**PRE-APPLICATION CONFERENCE MEETING
October 3, 2013**

SUBJECT: Second floor bath addition, window replacement, siding replacement, garage modification and covered porch addition

ATTENDEES: Applicant: Kristine Webb
Staff: Sara Javoronok, Associate Planner

Existing garage

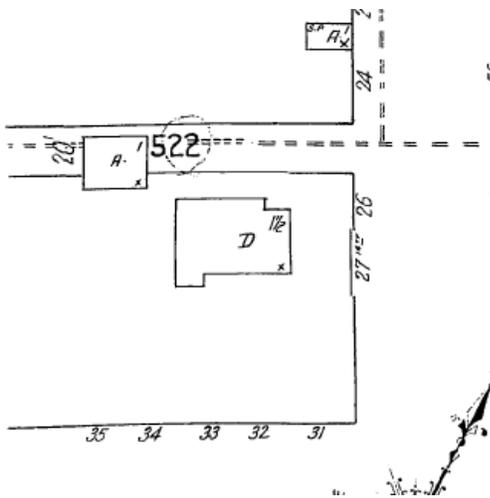
Existing and proposed elevations are required and need to show the existing and proposed height. Single story accessory structures are limited to 15 feet, and structures that are taller will be considered two-story accessory structures. Single story accessory structures can be sited within three feet of the property line and two-story structures must be setback 15 feet. The proposed changes would make the garage 19 feet, which would make it a two-story structure per these standards. **If you decided to add on to the front of the structure, there must be three feet between the garage and other structures per building code requirements. Other yard setback requirements are in CDC 25.070(C).** Given these requirements, if changes are made, staff recommends retaining as much of the existing siding as possible and reusing. In addition, the cut sheet or other information will be required for the garage door, any additional entry doors, and windows. Staff would recommend retaining and reusing the existing window. The code requires differentiation between old and new, which may not be proposed in this case. Provided that it meets the other requirements, deviation from this may be considered through a modification of design standards (CDC 25.080) that would allow for variations from the standards. **In addition, you will need to consult with the City Arborist, Mike Perkins, 503-723-2554 or mperkins@westlinnoregon.gov regarding any trees that are affected.**
